Service Bulletin

Subject: Front Seat Cushion Cover Detached/Loose from Front of Seat Frame

Models: 2011-2012 Buick Enclave
2011-2012 Chevrolet Traverse
2011-2012 GMC Acadia

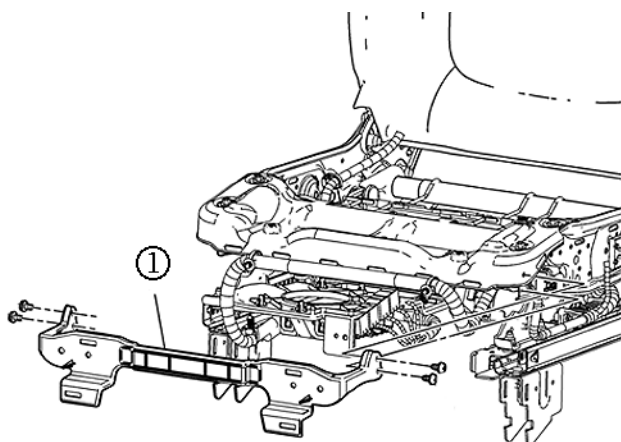
Some customers may comment that the front seat cushion cover J-channel may become detached from the seat frame, causing the seat cushion cover to be loose along the front edge of the driver or passenger seat.

The cause of this condition may be that the stack up of tolerances for the seat cushion cover size and the seat frame stamping may allow the front J-channel to become loose from the seat frame flange.
